City of Plymouth Planning Commission

Regular Meeting Agenda

SP23-04: 885 Starkweather
Special Land Use and Site Plan Review
Zoned: B-1, Local Business District
Applicant: Don Soenen

**Special Land Use and
Site Plan Review
For
Plymouth, Michigan**

Figure 2. Subject Site, Neighborhood Context & Traffic Control

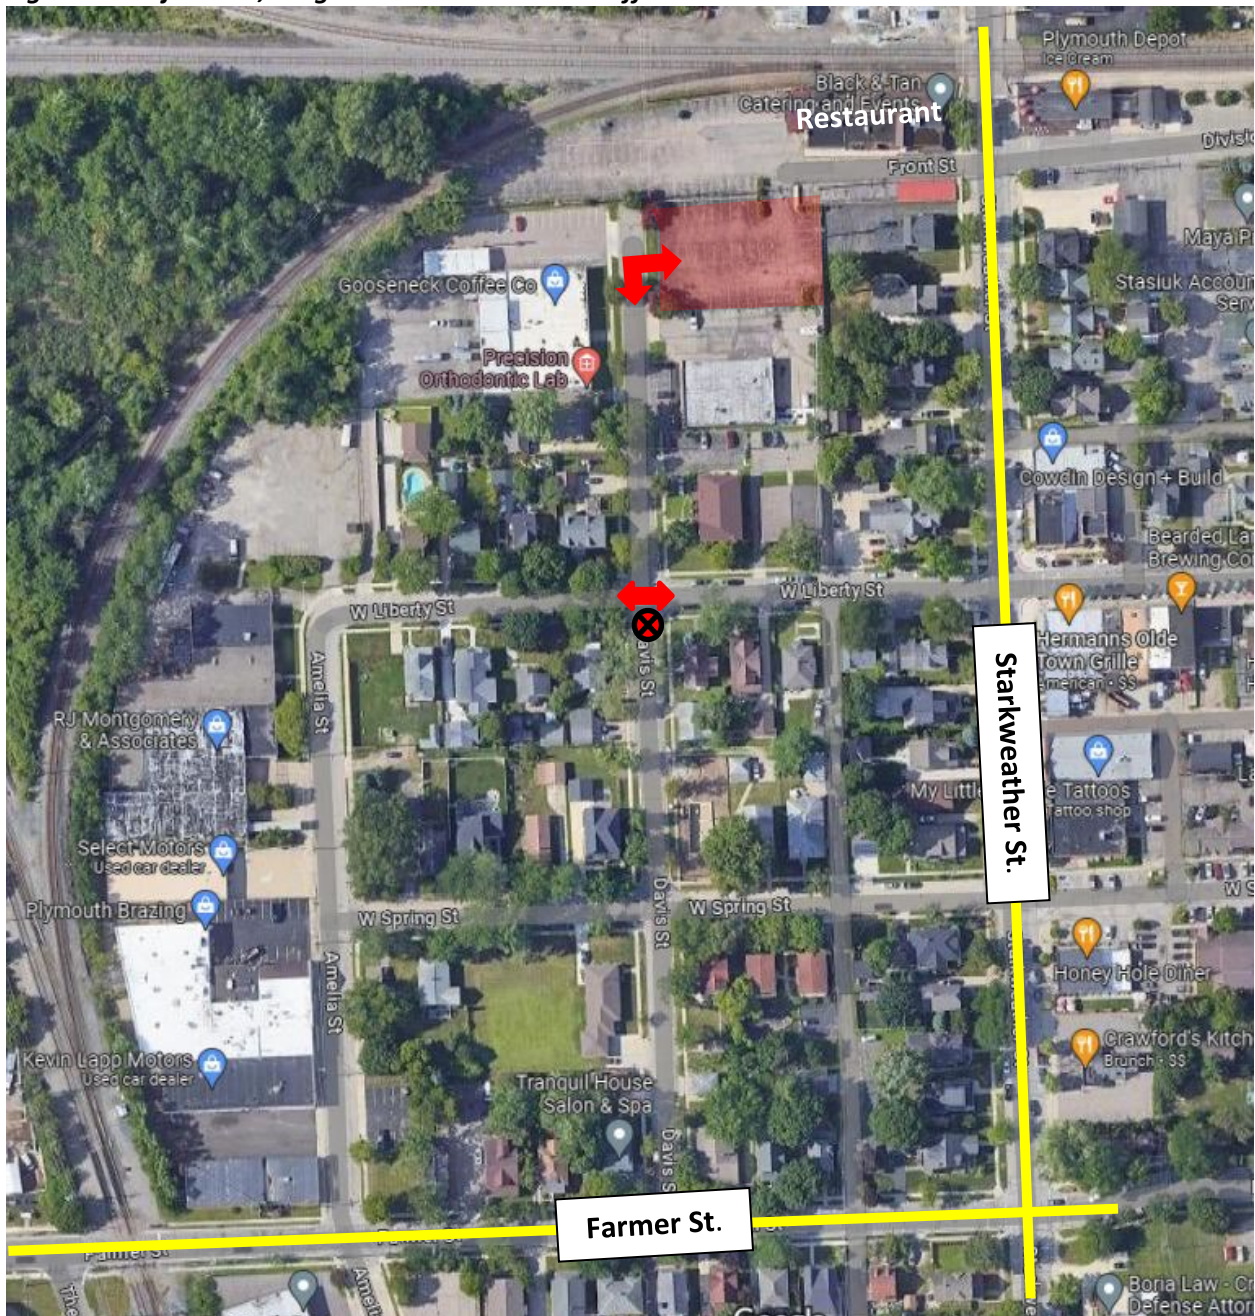
The project is proposing to add a driveway from the southern parking lot to Davis Street. This will increase traffic on this street into the adjoining neighborhood. The existing conditions create a “dead-end” condition for Davis St. In our opinion, this driveway will improve vehicular circulation for this site, but it will also increase traffic into the neighborhood to the south.

How does this number of vehicle trips compare with the current number of vehicle trips using Starkweather and Davis streets? SEMCOG Traffic Count Data is available for Starkweather St., which is considered a “major collector” road. Major collectors funnel traffic from residential areas to arterial roads, with some providing direct access to residences. SEMCOG’s Traffic Count Data indicates an annual average daily traffic (AADT) count of 3,200 vehicle trips on Starkweather. Davis St. is considered a “local road,” which are neighborhood streets that provide access to residences. No traffic count data is available for Davis St. However, it is a “dead end” road, and provides access to a single-family residence, a multi-family building, and five businesses in this block. The building on the west side of Davis St. is occupied by four (4) of the businesses, and this building has a second driveway off of the adjacent W. Liberty St.

If the Planning Commission thinks that the traffic into the neighborhood to the south won't cause unreasonable disturbances, it may be possible to direct the traffic coming from the Davis St. driveway onto specific roadways. For example, given the "mixed use" nature of Liberty St. to the west of Davis St., and Liberty south of Davis St., it may be possible to direct traffic along Liberty St. by the use of some type of traffic control sign (such as "No Through Traffic" or "Do Not Enter after 9pm") installed on Davis St. at the intersection with Liberty St.

If the Planning Commission thinks this traffic would be unreasonably disturbing to the neighborhood, then another option would be to install the Davis St. driveway with a gate and Knox box. This way, the driveway would be available for emergencies, but would eliminate the traffic from this use into the neighborhood.

The Planning Commission may also want to request additional input from the City Engineer, Fire Chief, and/or Police Chief.

| DRAWN BY | DAB | SHEET | C-1 |

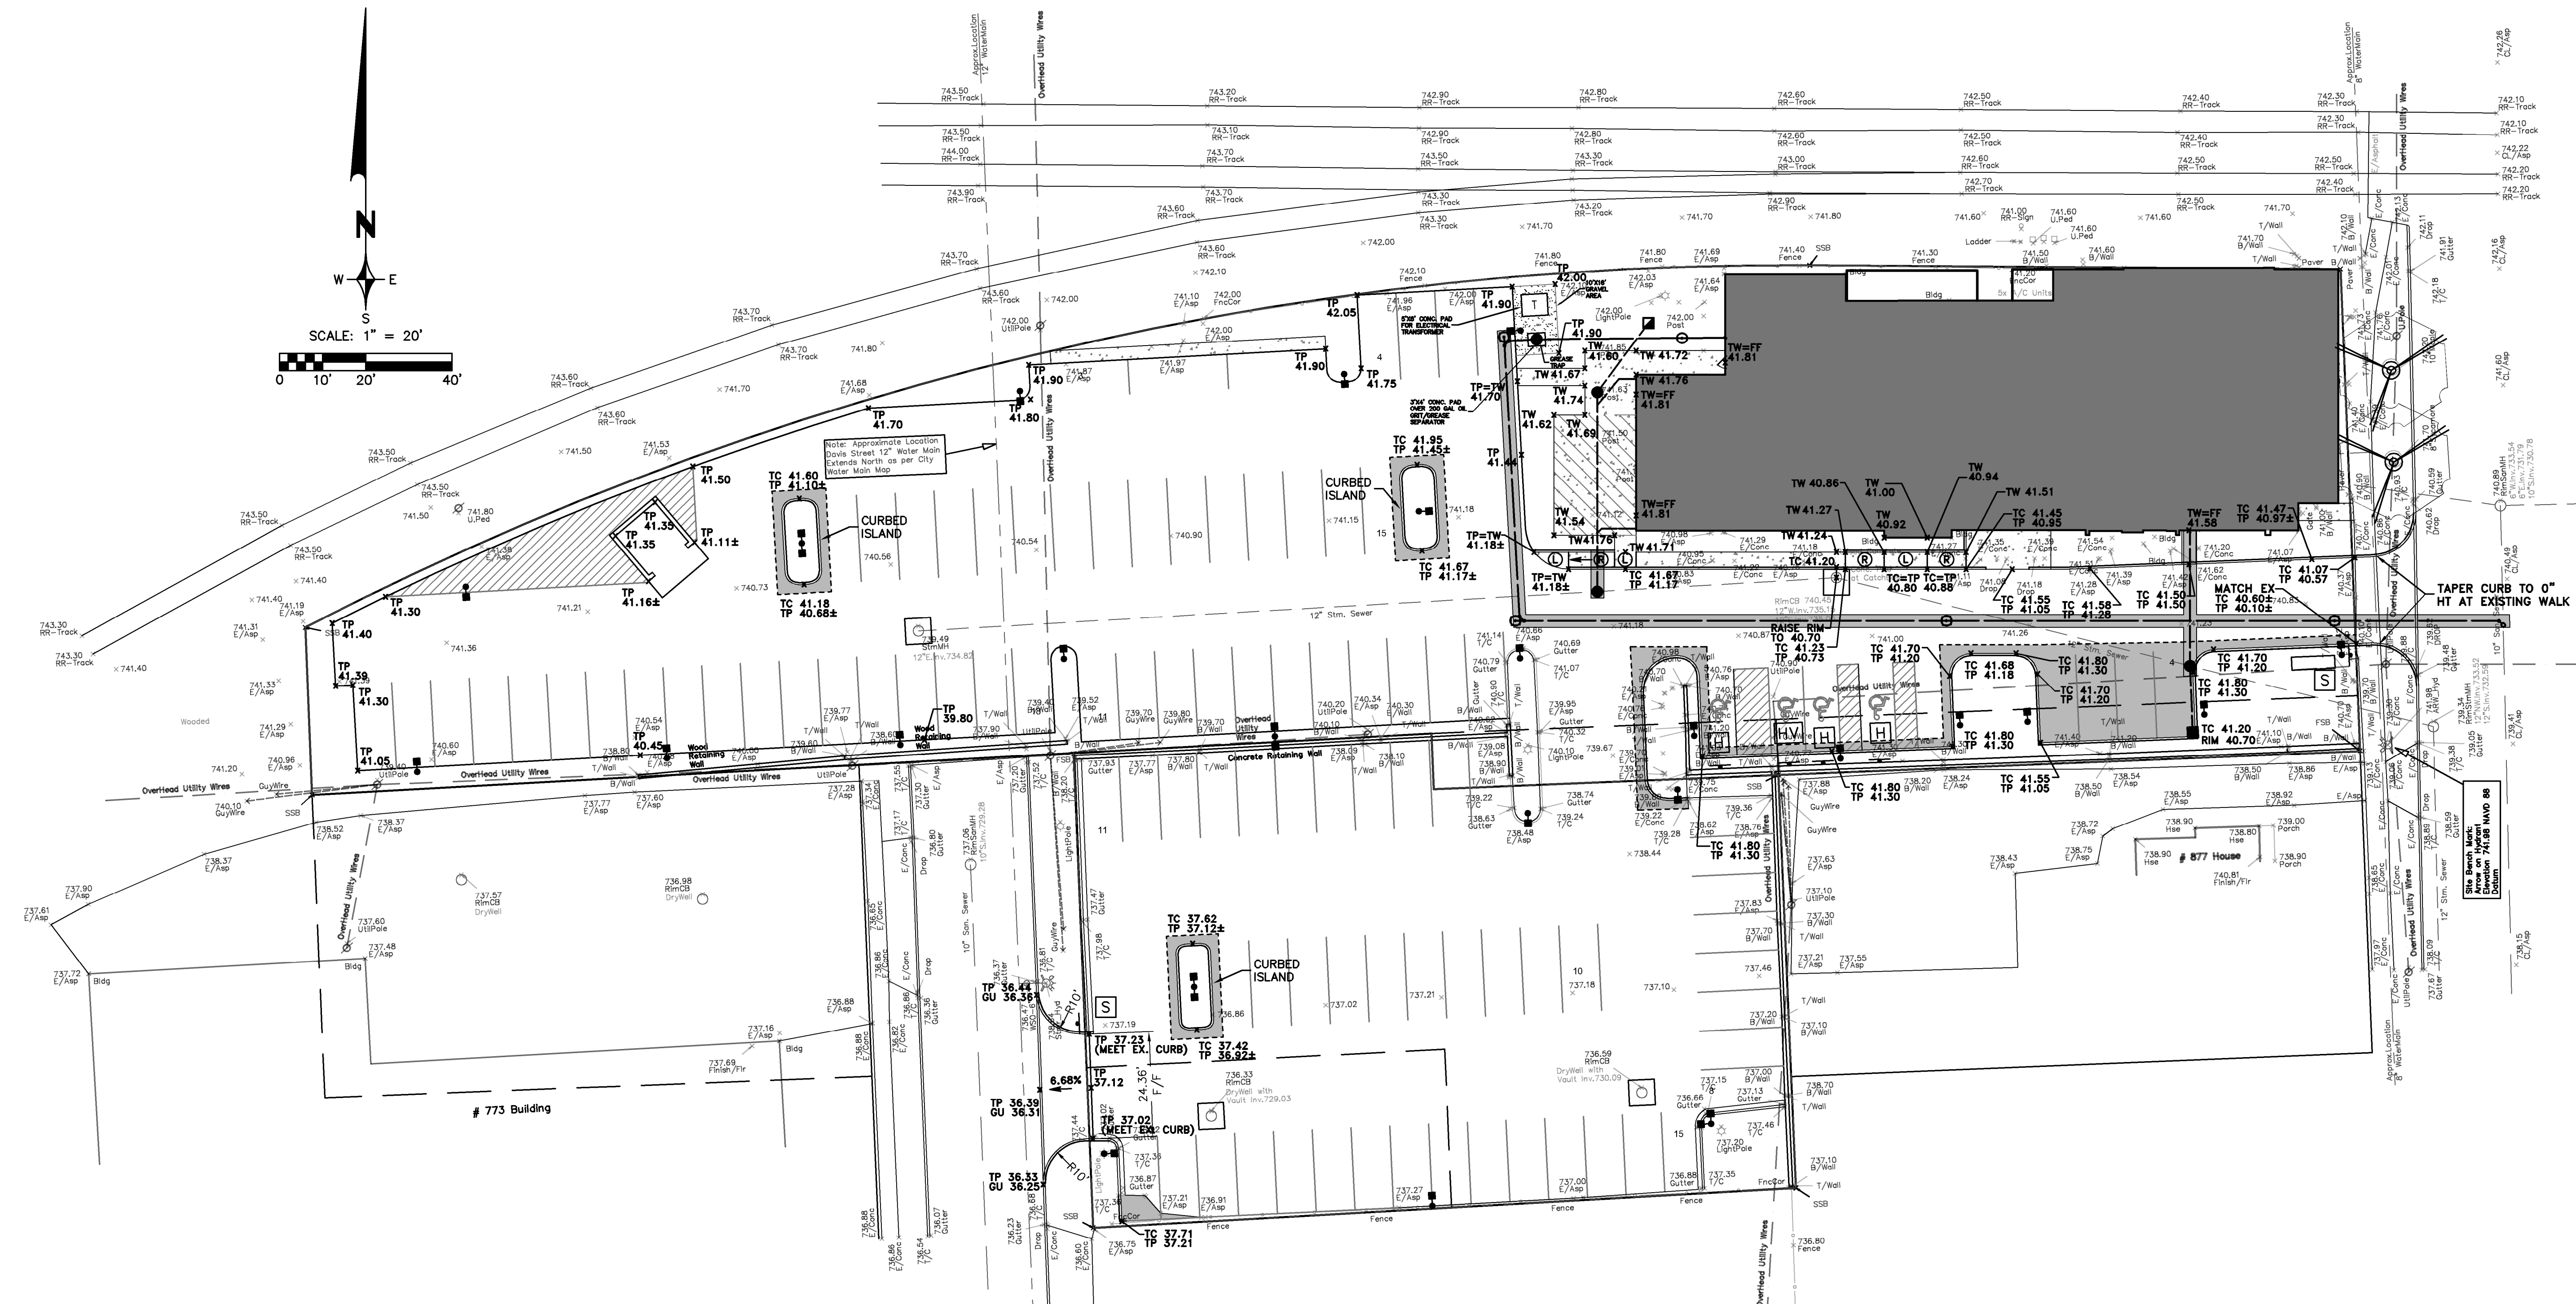
4. Sheet C-1, Note #14 calls for removing pavement in areas that will be landscaped. It also calls for removing 1-3” of existing soil or road base in these areas. This shallow excavation is insufficient to create a planting bed that would support any plant material, including perennials, shrubs and trees. The landscaped areas need to be excavated to a minimum of one (1) foot, and filled with appropriate planting medium to ensure the plants can live in these environments.
5. Sheet L-1 states that the turf areas and landscape beds will be provided with an irrigation system. What about the parking lot islands? These areas also need a consistent water supply.

5. Paint entire retaining wall (all sides).
 6. Modify Note 14 on Sheet C-1 to excavate new planting beds that had been paved to a minimum of 1-foot deep, and refill with appropriate planting medium.

| DATE | SCALE | HOR: 1" = 20' | VER: 1" = N/A |
|-----------------|---------|---------------|---------------|
| DRAWN BY DAB | SHEET | C-2 | |

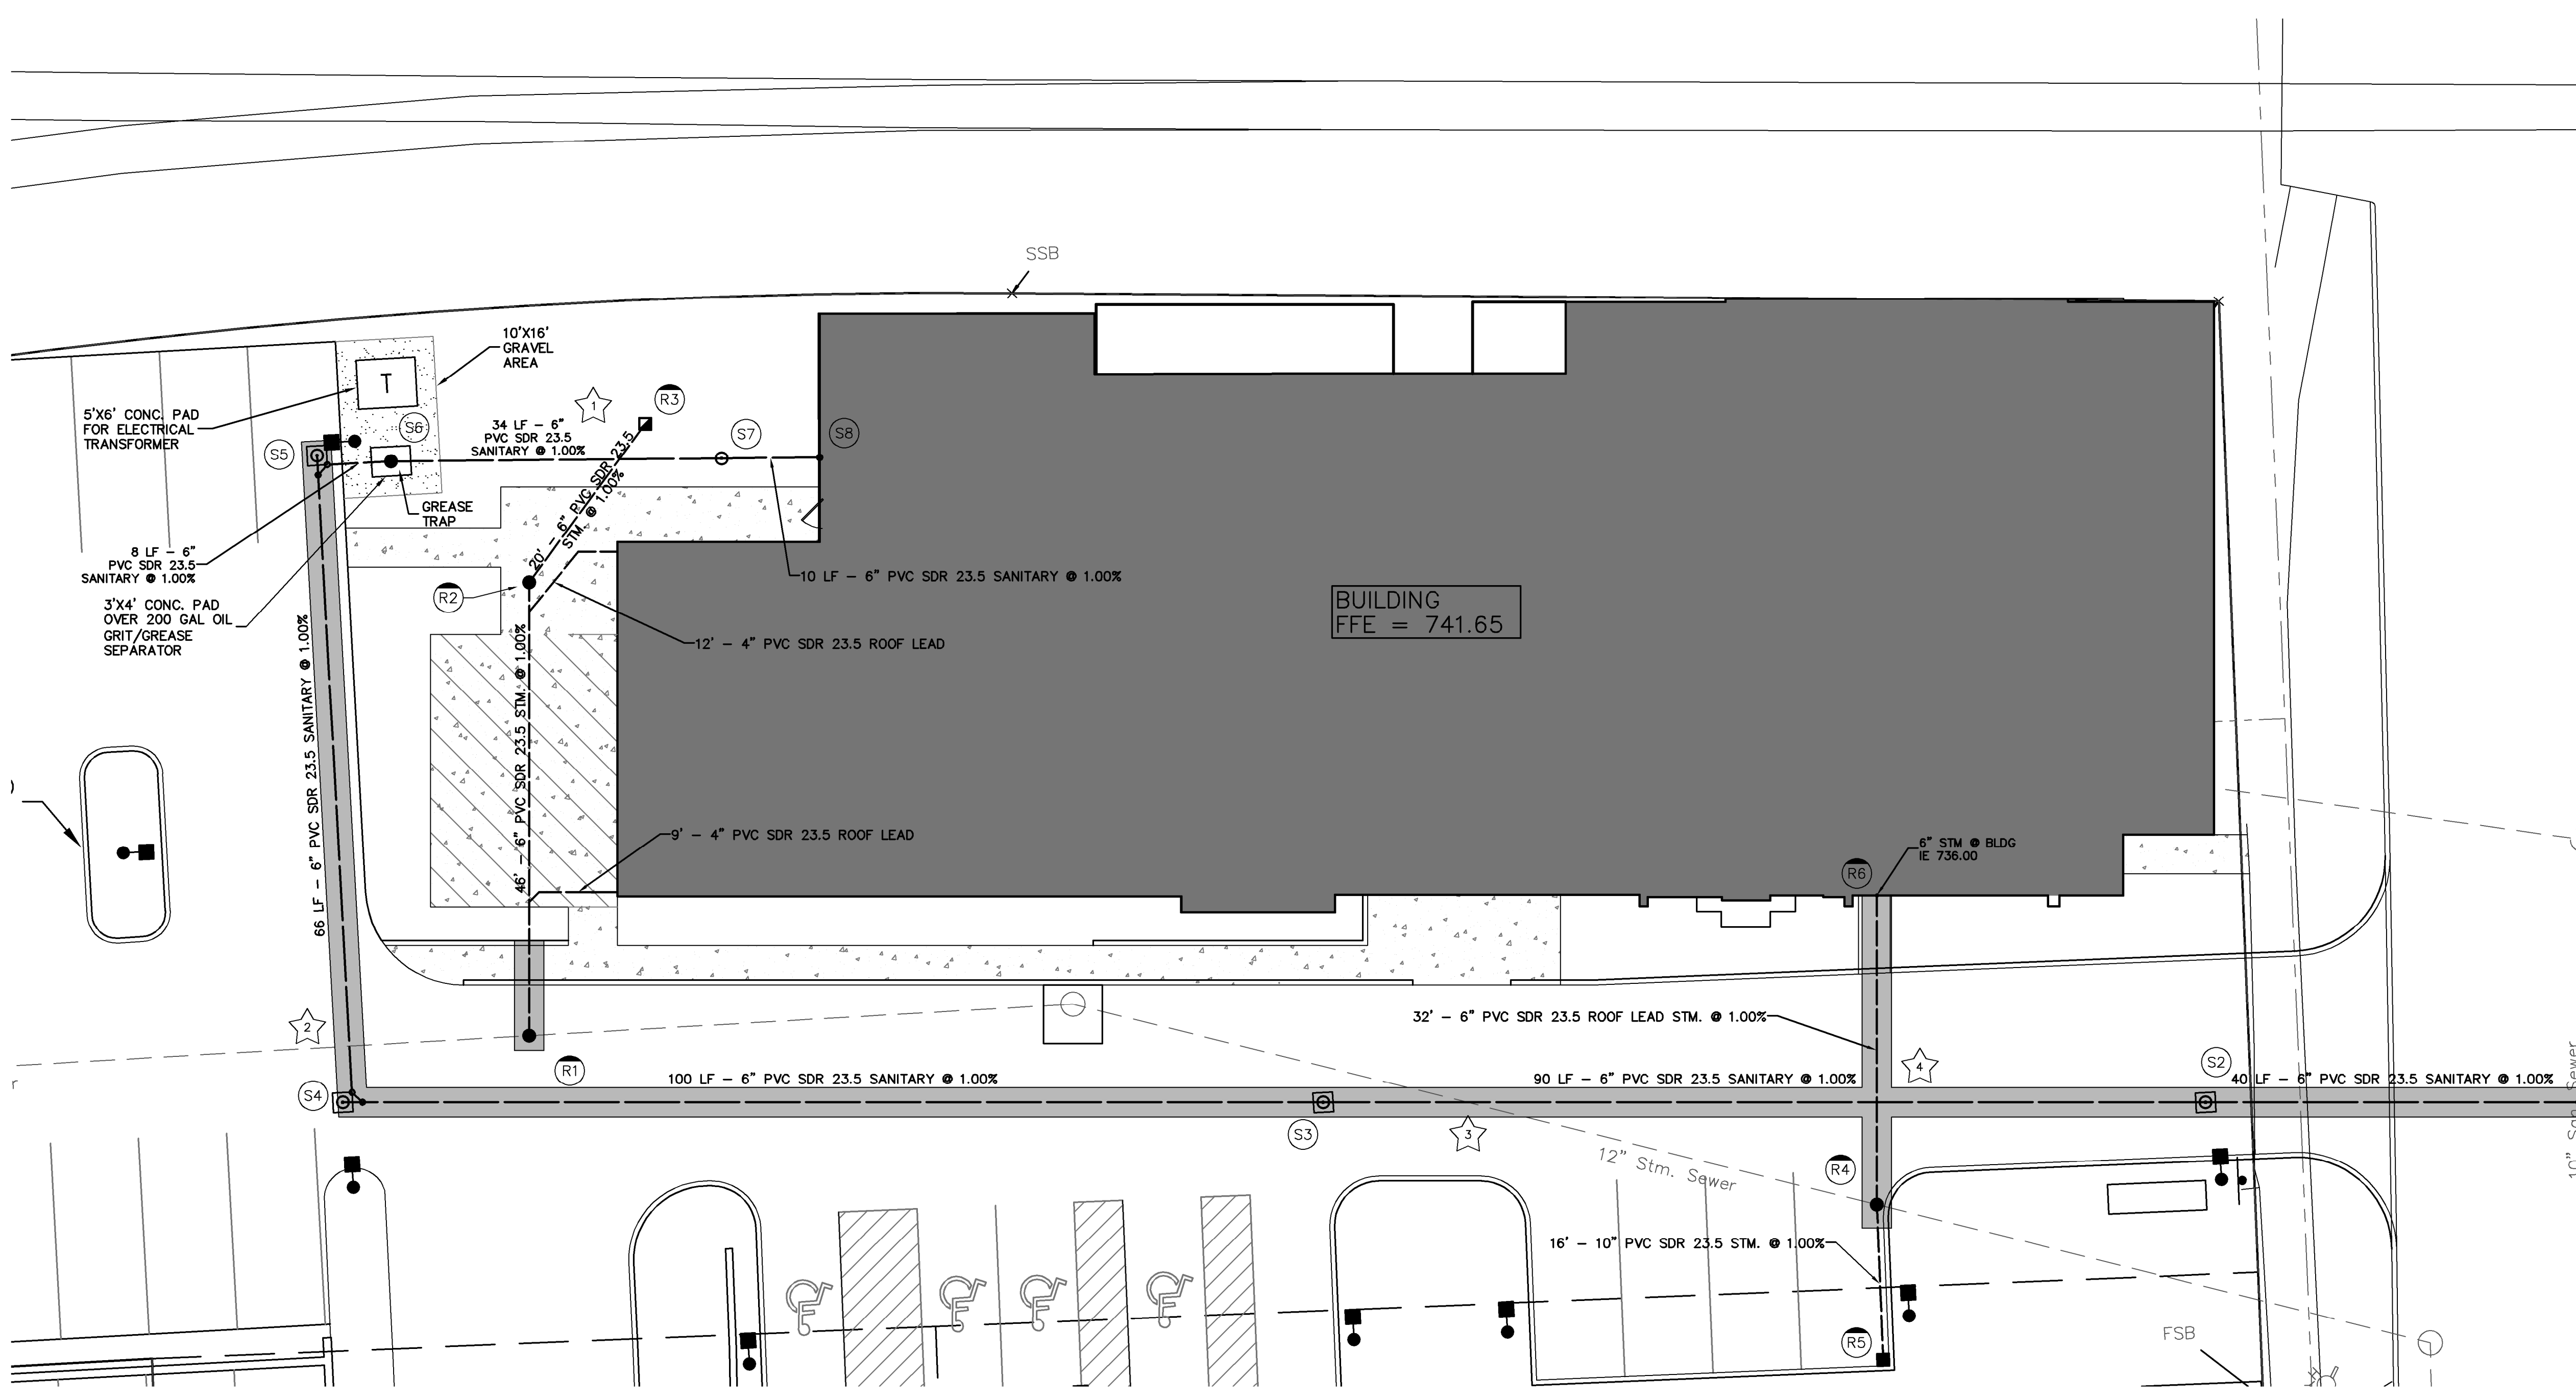
The plans show four (4) barrier-free parking spaces, where five (5) are required. However, we think the one space located just east of the 4 barrier-free spaces was intended to be a barrier-free space, as it is only 8-feet wide. It just wasn’t identified as barrier-free. The plans should be updated to show five (5) barrier-free spaces.

Loading/Unloading. A loading zone should be identified on the plans.

The frontage abutting Davis St. does not have a sidewalk. Sec. 78-351 requires a sidewalk to be installed along the site frontage to provide safe passageway for pedestrians. There are paved areas for pedestrians to walk along the east side of Davis St., up to the boundary of the south parcel. If the Planning Commission were to require a sidewalk along Davis St. to create a pedestrian connection with the project and the public walk along Davis St., the segment would be approximately 18-feet long.

Items to be Addressed: 1. Recommend Planning Commission consider the proposed number of parking spaces so that islands/landscaping can be installed to make this site less non-conforming. 2. Show five (5) barrier-free spaces on site plan. 3. Show loading zone on site plan.

Items to be Addressed: 1. *Defer evaluation of re-designed Starkweather St. driveway to City Engineer.* 2. *Planning Commission to determine if sidewalk segment along Davis St. frontage is required.* 3. *Applicant to consider adding bicycle rack.*
